MONTICELLO NUCLEAR GENERATING STATION

AMENDMENT TO PROVISIONAL OPERATING LICENSE

Amendment No. 21
License No. DPR-22

TS B.2.4-RADIOACTIVE EFFLUENTS

Figure TS B.2.4-1 Off-Gas Storage Tank Gross Activity Limits

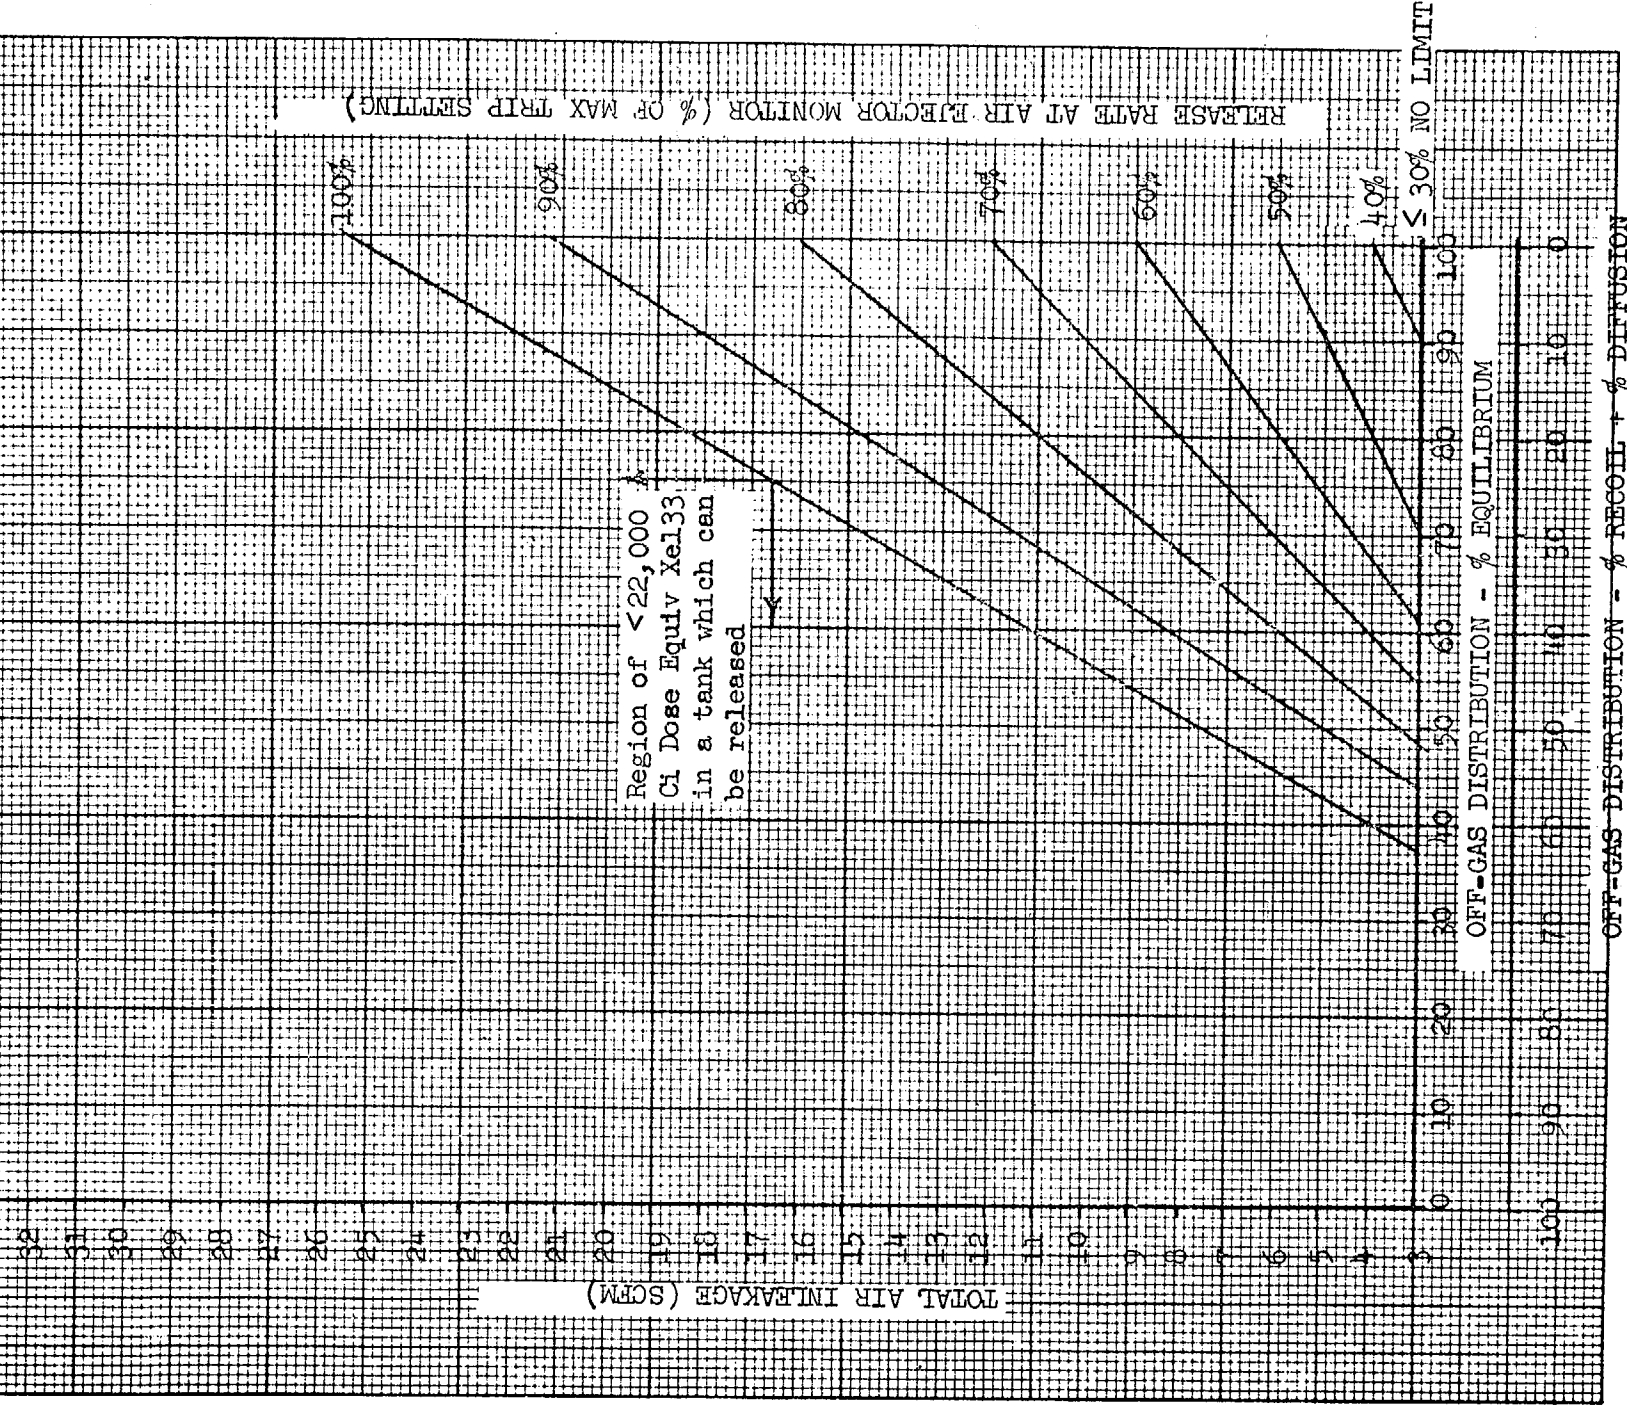
Pages 1v
68
168
169
170
171
172
173 - 179 (Delete)
B.2.4-i (Add)
B.2.4-ii (Add)
B.2.4-1 thru B.2.4-19 (Add)
Tables B.2.4-1 thru B.2.4-5 (Add)
Figure B.2.4-1 (Add)

Calculations have been performed to determine the relationship between steam jet air ejector offgas activity and composition and condenser air inleakage. These calculations were used to determine the curves presented in Figure 2.4-1. The results of the measurement of condenser air inleakage and the average air ejector offgas release rate are used in conjunction with the

most recent offgas isotopic analysis to determine if the maximum permitted Xe-133 dose equivalent tank radioactivity contents may be exceeded. This analysis is adequate to initiate corrective action in the unlikely event that the tank radioactivity limit is being approached.

- j. The maximum gross radioactivity contained in one gas decay tank after 12 hours holdup that can be discharged directly to the environs shall be less than 22,000 curies of Xe-133 dose equivalent.
- k. The mechanical condenser vacuum pump shall be capable of being isolated and secured on a signal of high radioactivity whenever the main steam line isolation valves are open or it shall be isolated.
- l. At least once during each operating cycle automatic isolation of the mechanical condenser vacuum pump shall be verified.
- m. An unplanned or uncontrolled offsite release of radioactive materials in gaseous effluents in excess of 5 curies of noble gas or 0.02 curie of radioiodine in any one hour period shall be reported within 30 days.
